## SERVICE BULLETIN

**APPLICABILITY:** 2014-19 Legacy & Outback **NUMBER:** 07-223-23  
**SUBJECT:** New Genuine Subaru Replacement Battery (SOA821B950) **DATE:** 07/11/23

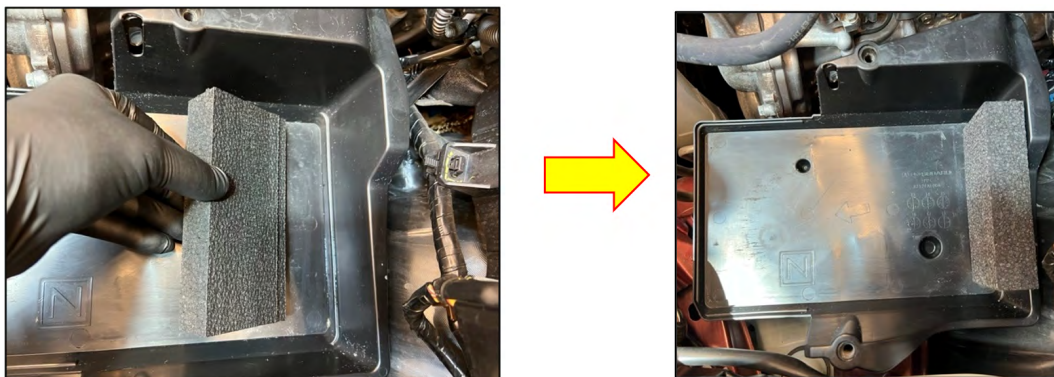
**STEP 1:** Remove the battery as per the applicable Service Manual: Engine > STARTING/CHARGING SYSTEMS > Battery > Removal
